April 12, 2021 Case #2021-214

Request: Conditional Use and site plan request for an indoor golf facility.

Hudson Planning Commission	SITE PLAN REVIEW
Case No. 2021-214, 2019	April 12, 2021

SCALE AS NOTED

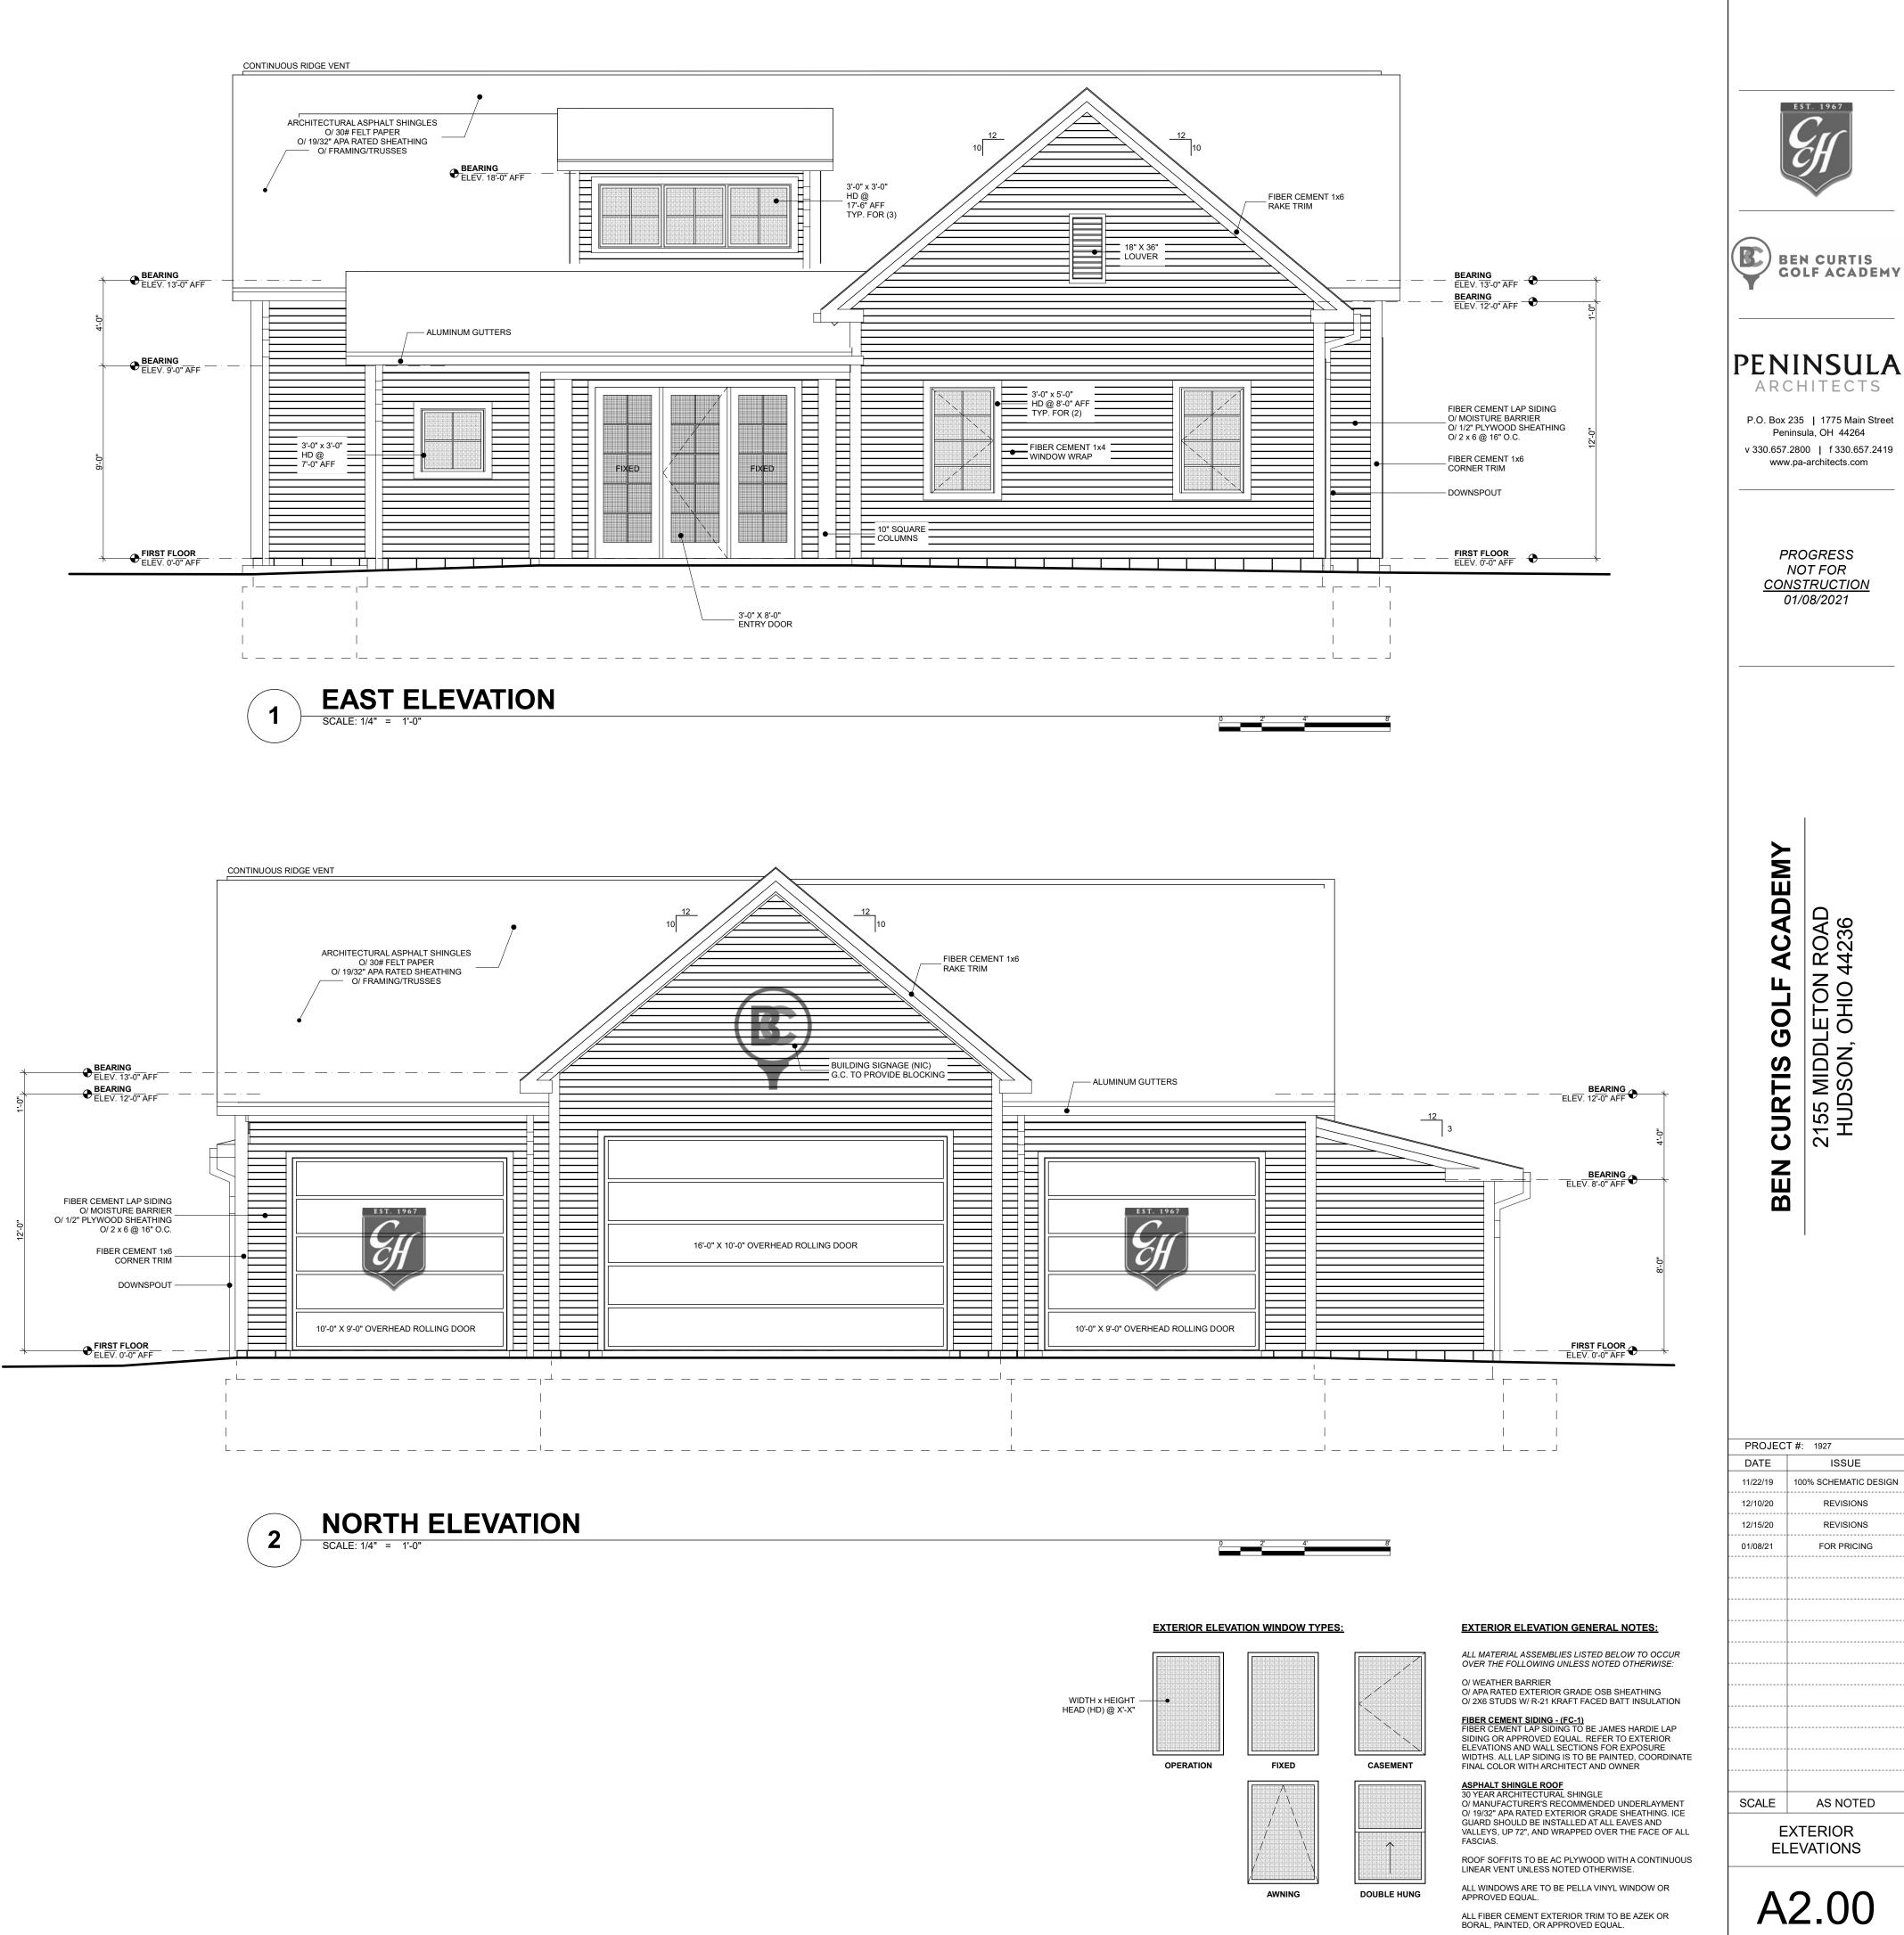
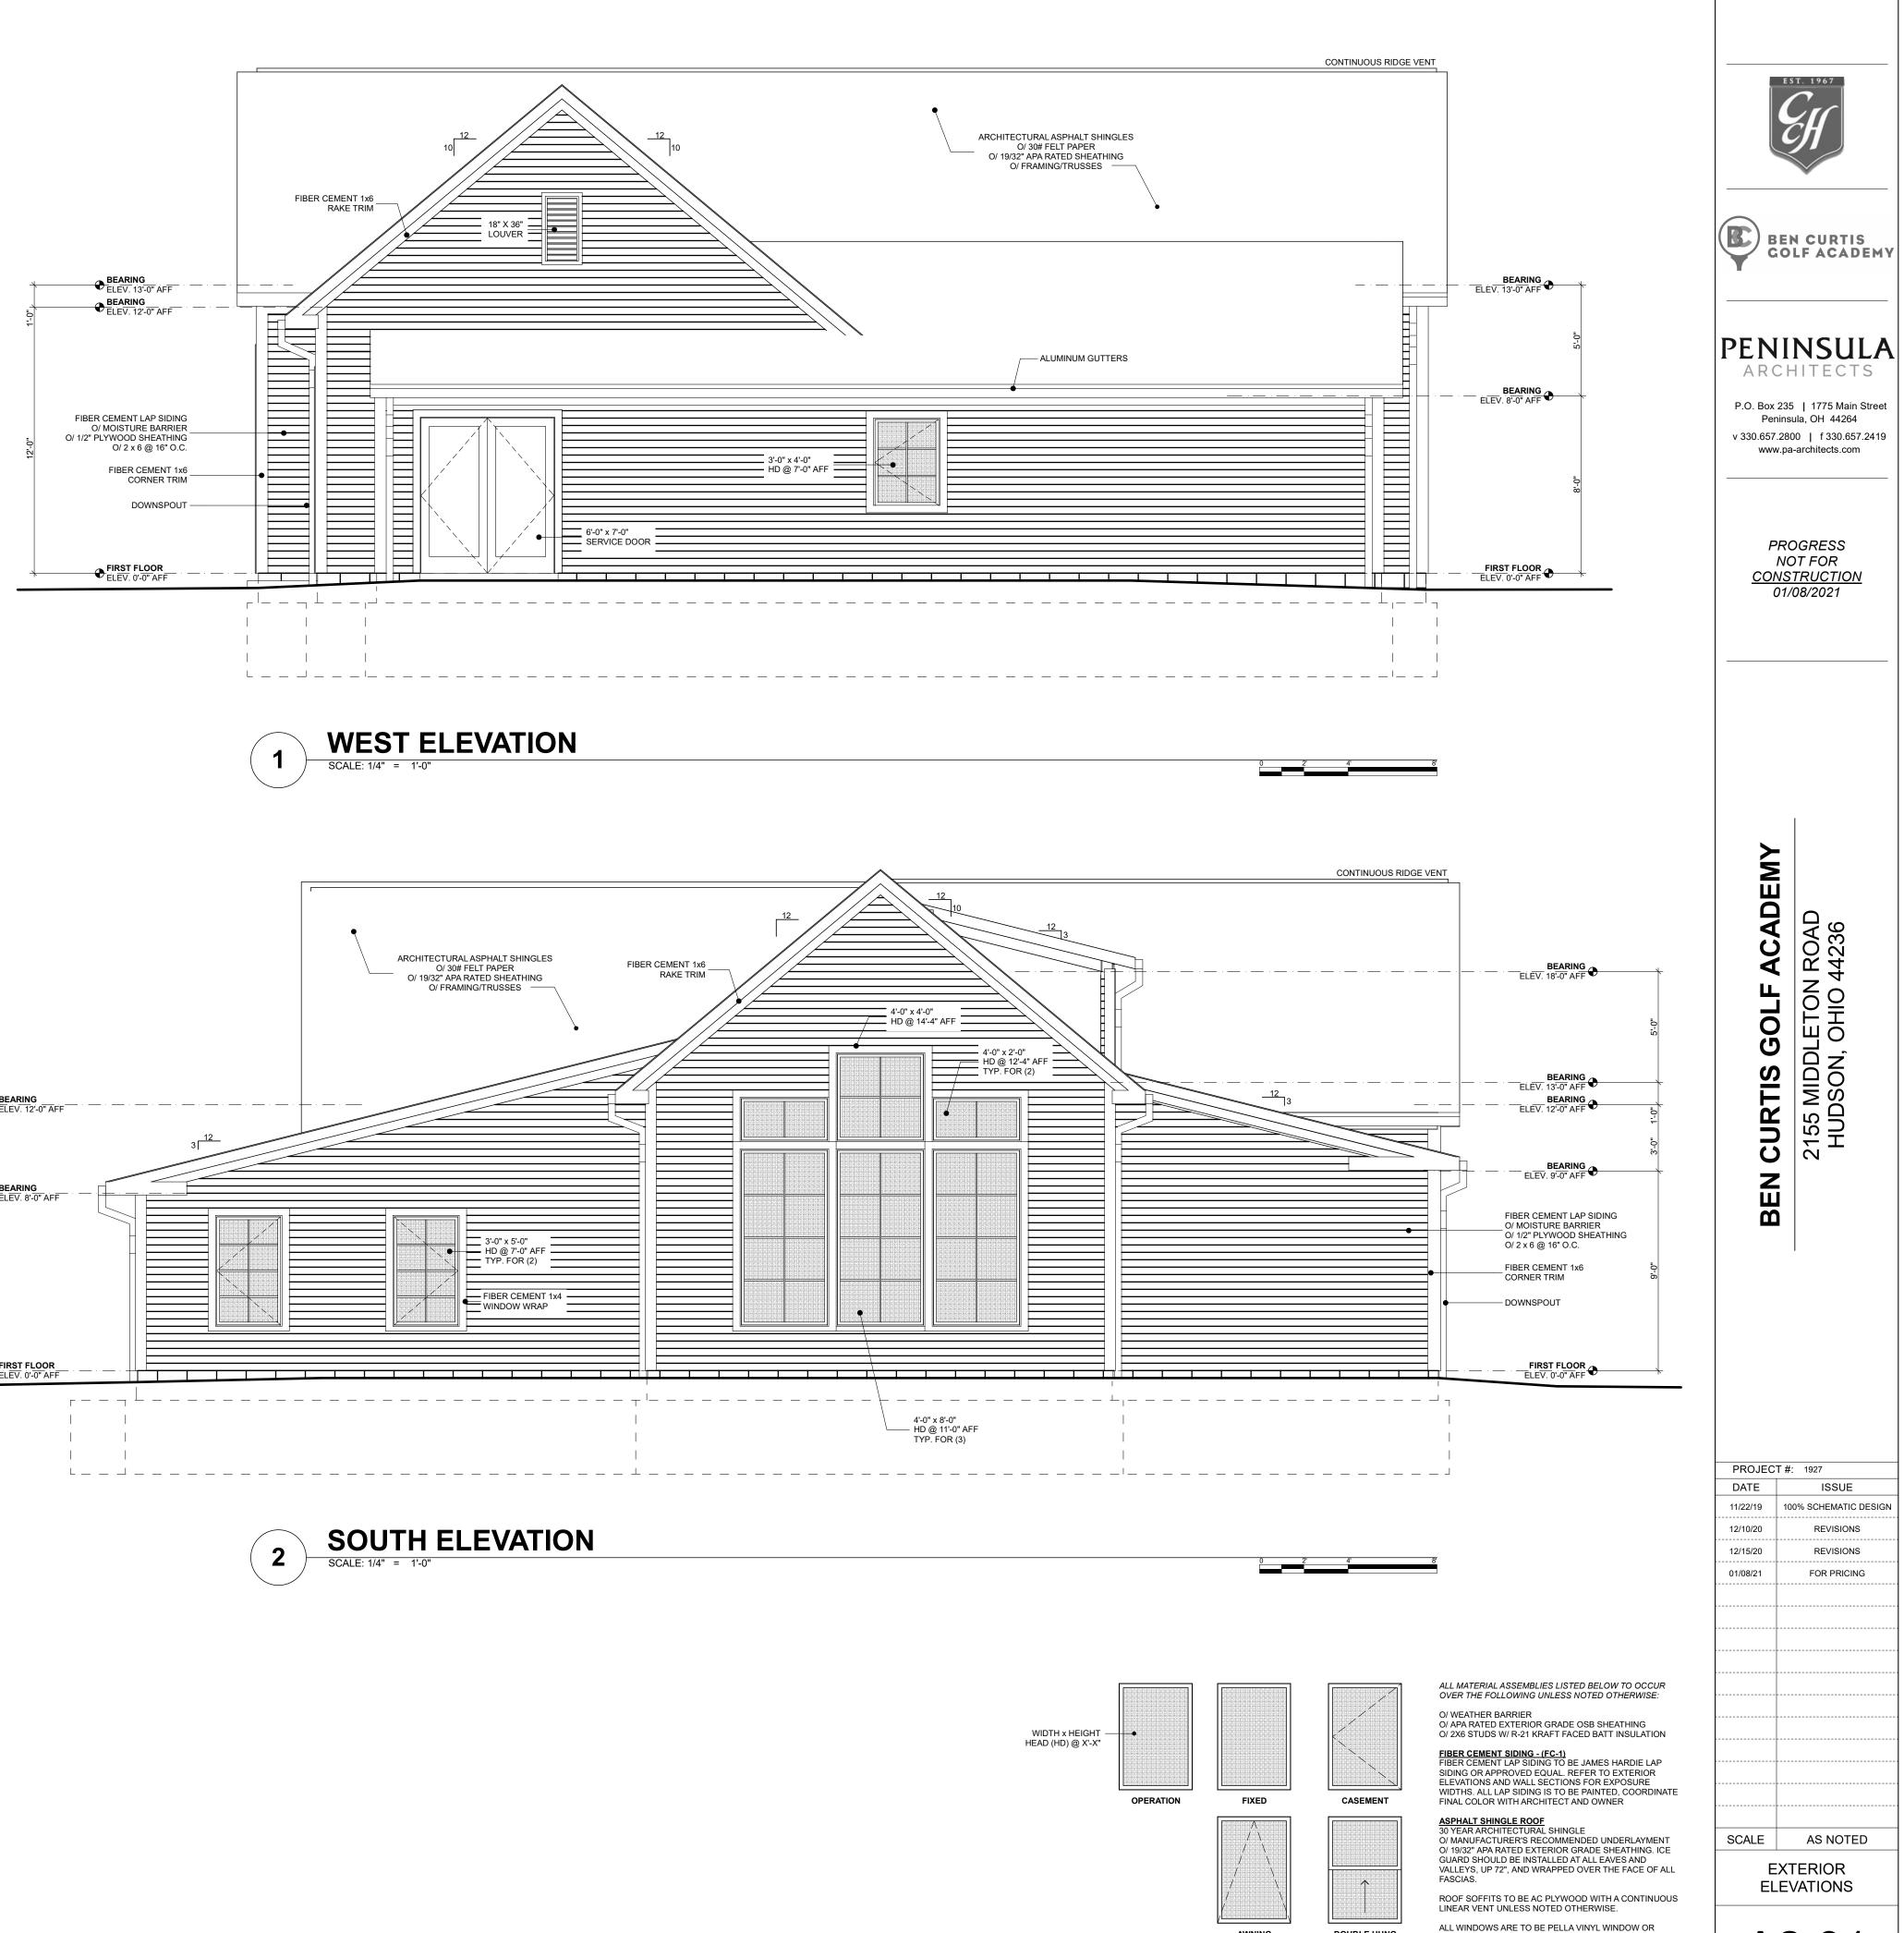
- Noise: The facility has been described by the applicant as an indoor golf training facility, however; staff notes three overhead doors proposed on the north wall. These doors would lead out to the existing driving range from the proposed training bays. Question how these doors would be utilized with the overall operation of the facility. Additionally, staff suggests relocating the equipment doors to the north elevation to minimize impact on adjacent residential uses. Finally, outdoor speakers/music should be prohibited due to the proximity of the building near Garden Lane.

- 6. Outdoor speakers/music shall be prohibited.
- 7. Equipment room doors shall be relocated to the north elevation.
- 8. Construction activity including staging area, waste container area, and concrete washout be located a minimum twenty-five (25) feet from the western property boundary.
